THE MARYLAND-NATIONAL CAPITAL PARK AND PLANNING COMMISSION

MEMORANDUM

REVIEW TYPE: Site Plan Review
[See also Preliminary Plan No. 1-02099 submitted for concurrent review]

PROJECT NAME: Silver Spring Square [former Canada Dry Bottling Plant]
CASE #: 8-02040

Attachment 5- Site Plan

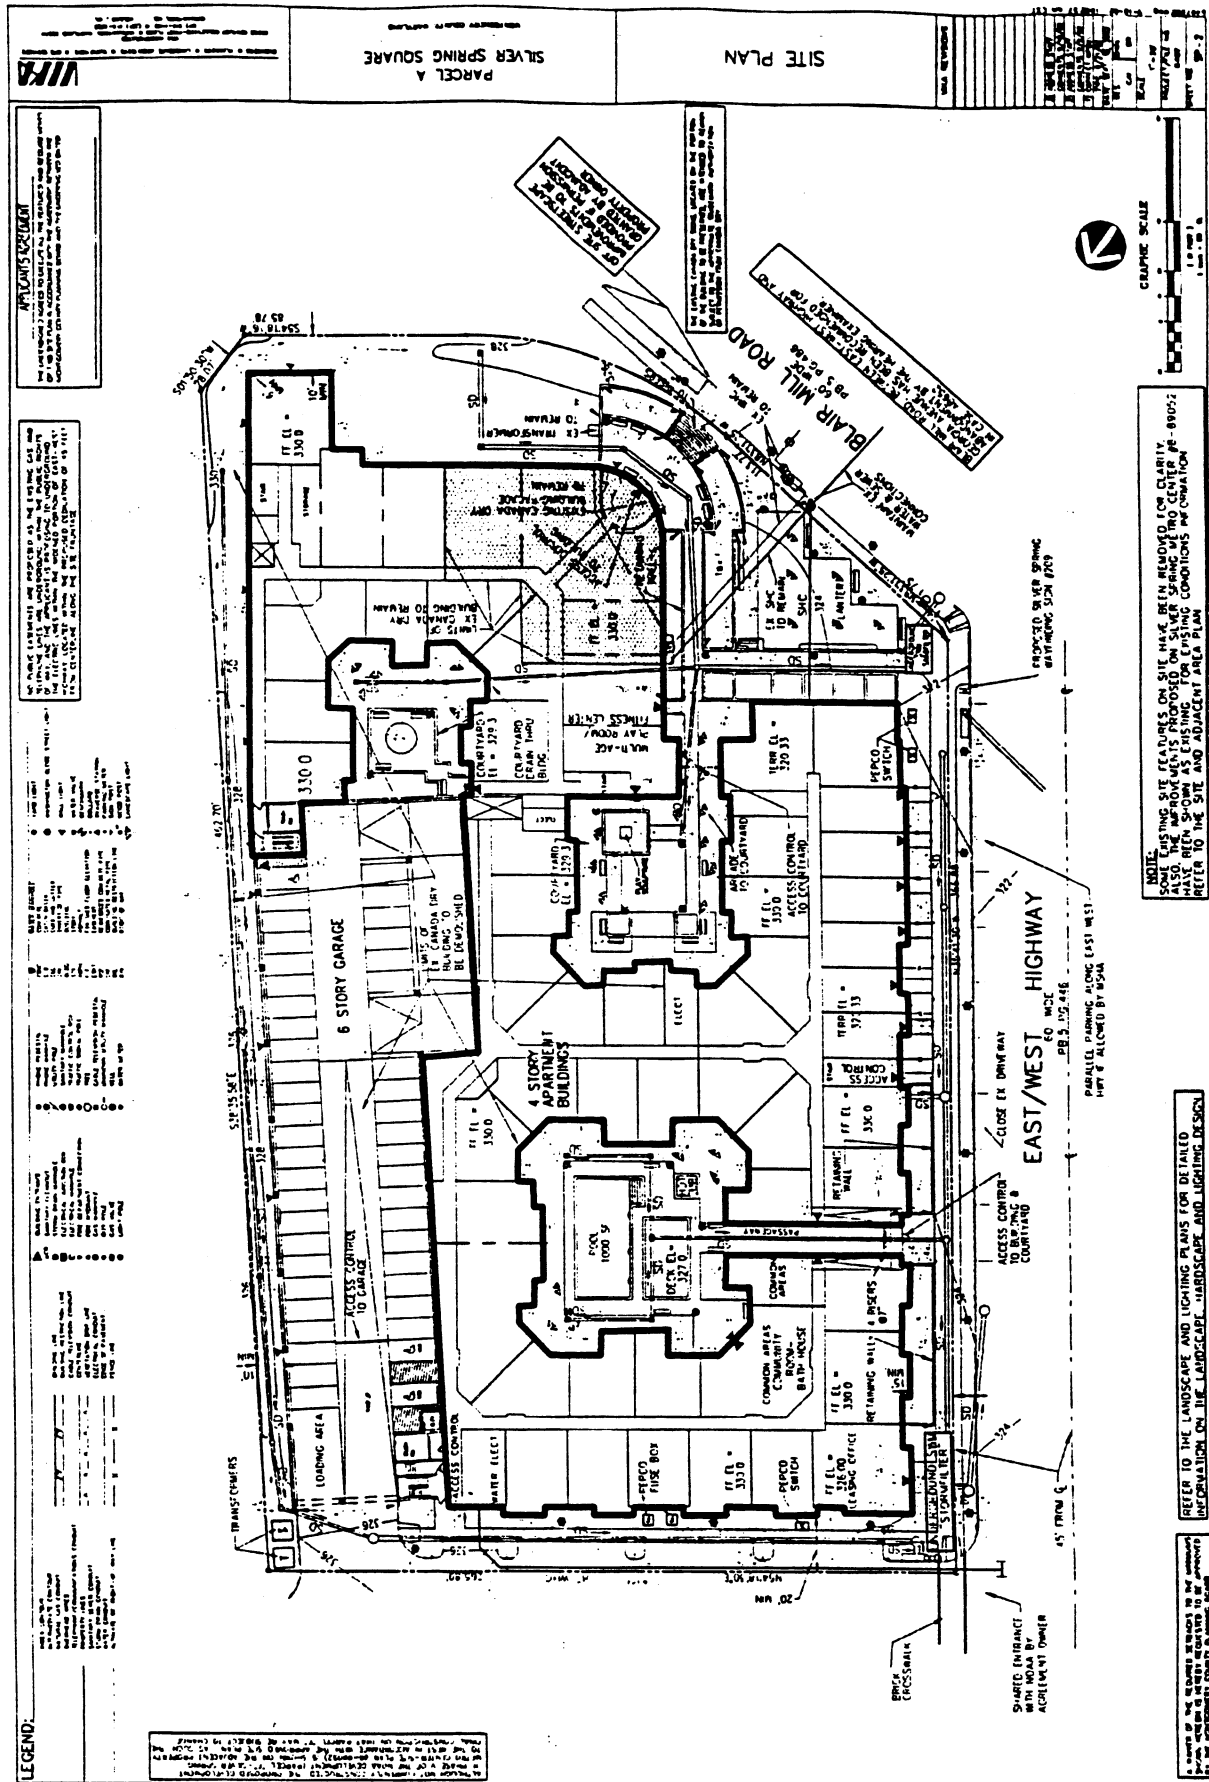
- a. Coordinate with the Silver Spring Regional Service Center and delineate on the drawings the location of any proposed Silver Spring wayfinding signs.
- b. Relocate all overhead utilities underground.

- c. Show where the location of the "Canada Dry" signs will be located on the building subject to Condition 1(g) above. The existing street side sign should be maintained in its current location. Relocate the existing track side sign to a new location on the track side of the new building or parking garage.
- d. Provide information on final exterior building materials.
- e. Provide specifications for controlled access (gate, card reader, etc.) to the parking garage.
- f. Provide dimensions and area for all indoor recreation amenities (fitness facility, multi-age playroom and community room).
- g. Secure a waiver from the Montgomery County Health Department for a reduction in the size of the swimming pool. In the event that the waiver is not granted, submit revised Site and Landscape Plans for staff approval.
- h. Show final location and unit type of all MPDU units within the building.

Attachment 10a- Landscape Plan

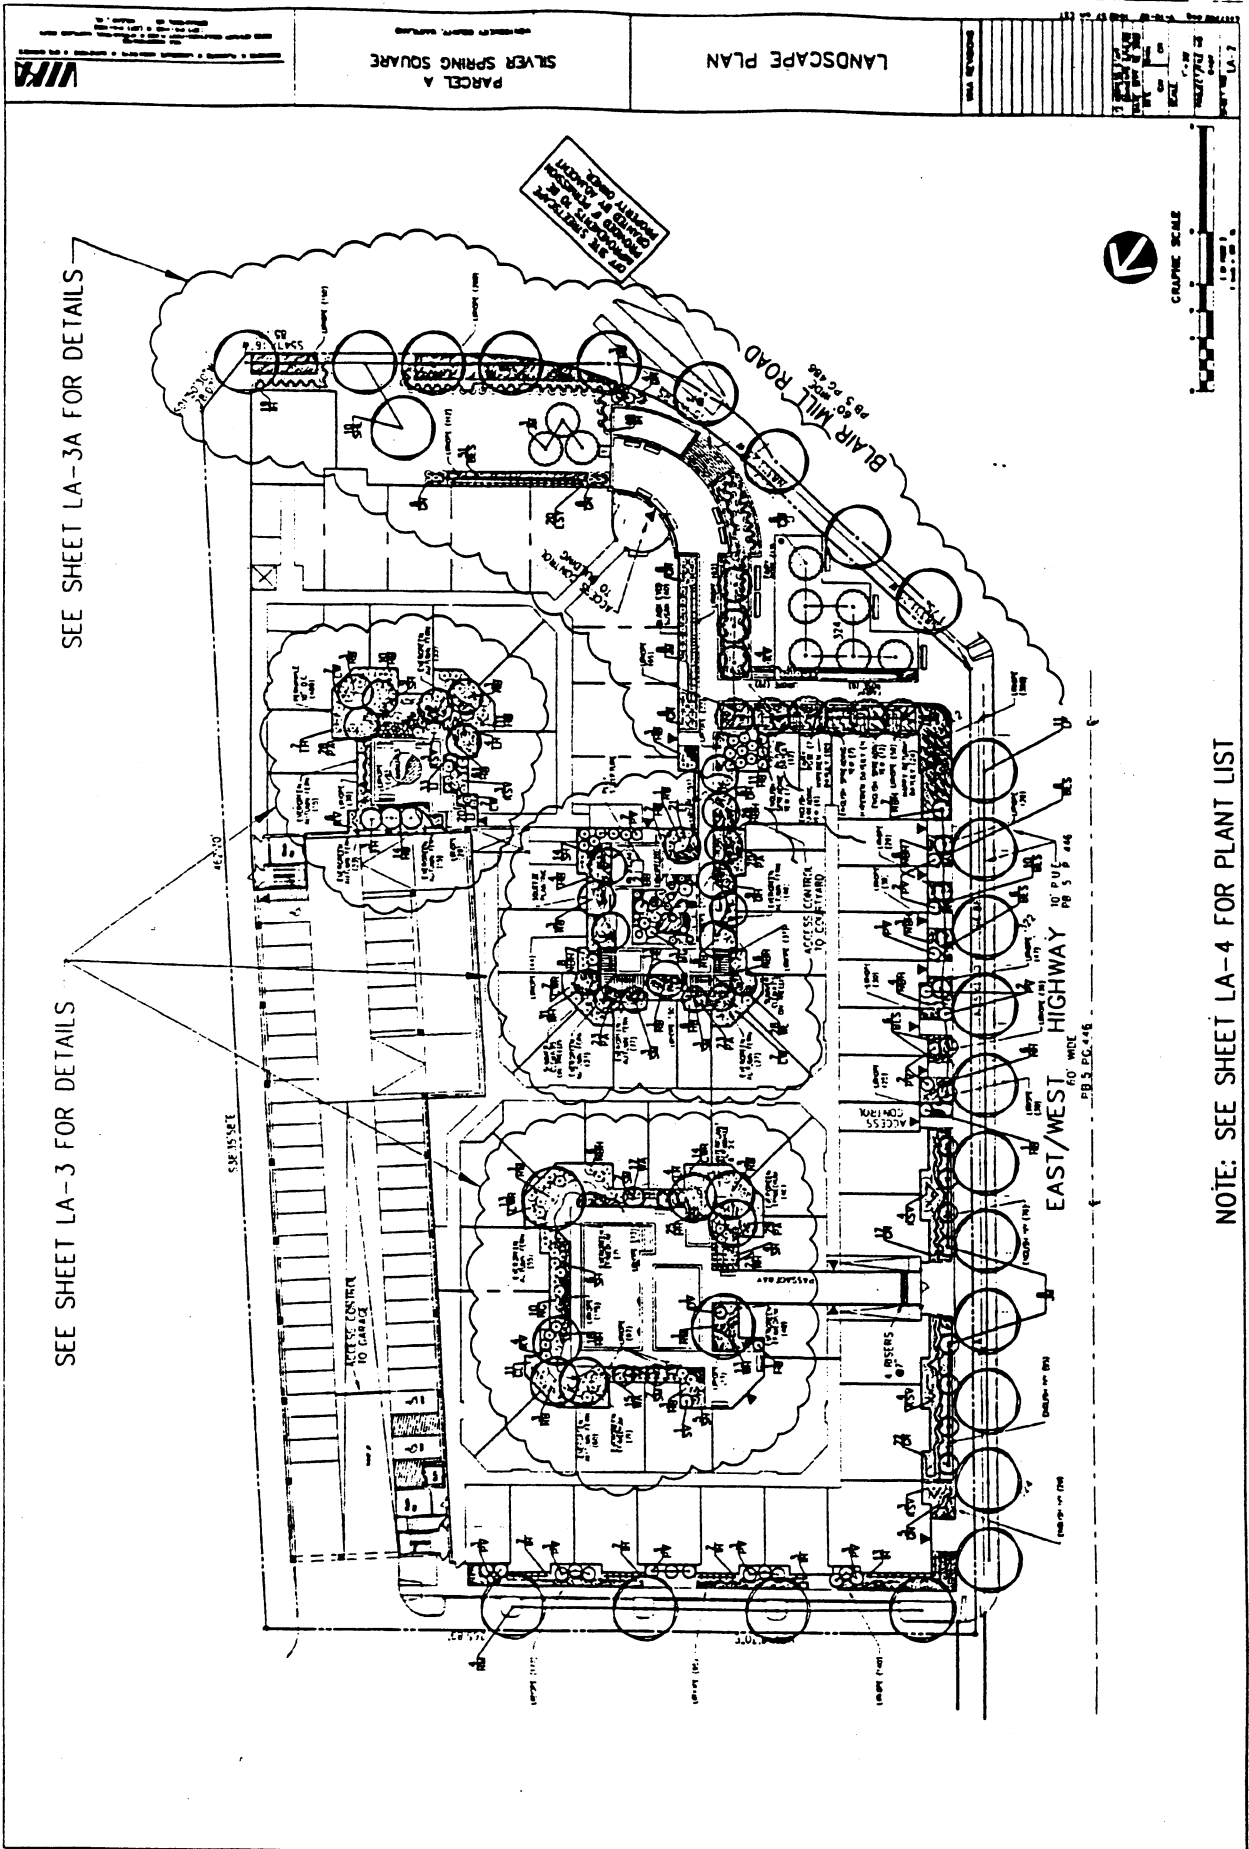
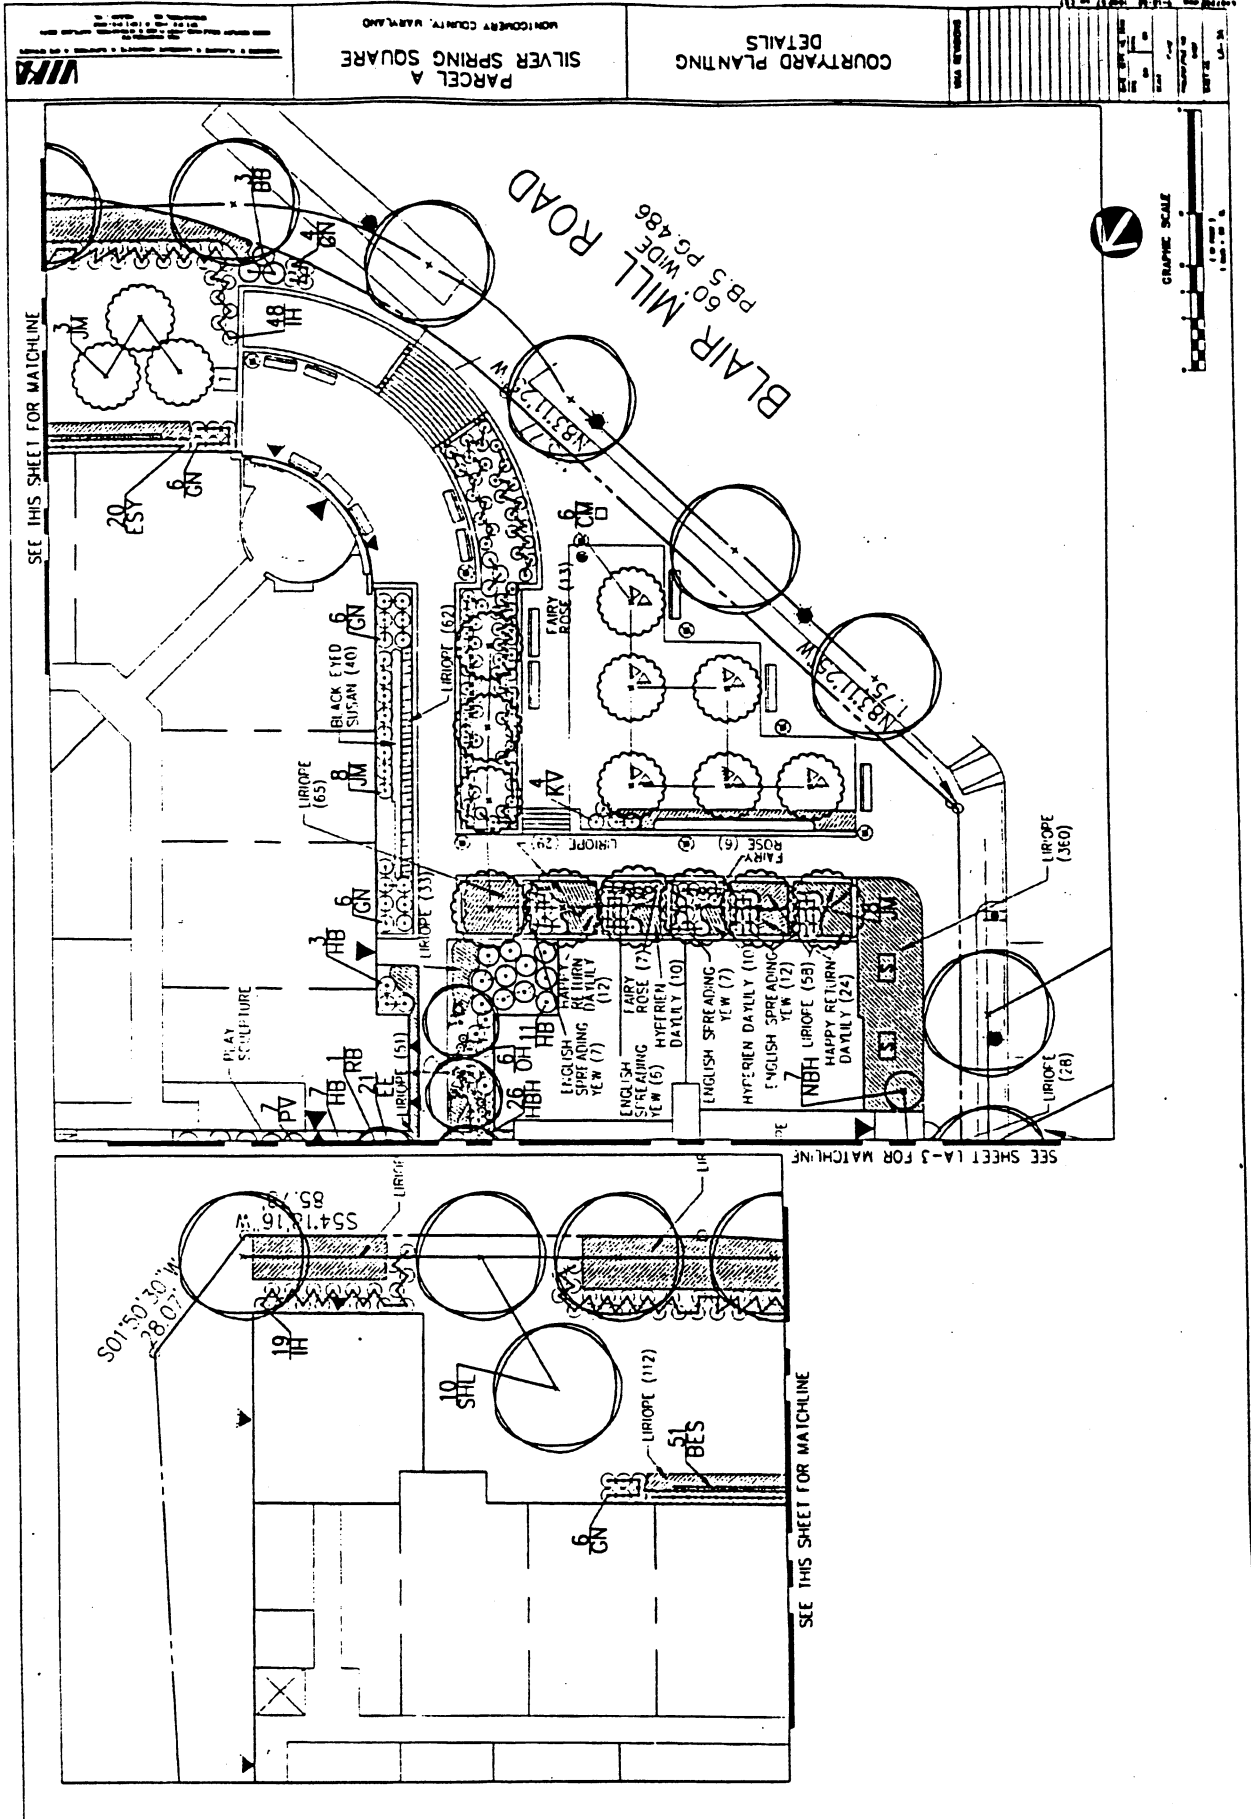
- i. Provide streetscape improvements in accordance with the *Silver Spring Streetscape* (April 1992) technical manual or as amended.
- j. Provide street trees at 3-3.5" caliper at the time of planting.
- k. Provide additional landscape screening for all above ground transformers and switches.
- l. Provide details of all site and building signage.
- m. Provide details on the commemorative plaque located in the primary public plaza including the final location, message, dimensions and materials.
- n. Provide details including materials and dimensions for all proposed site walls, ornamental fencing, gates, paving, furniture, play sculpture and other site amenities.
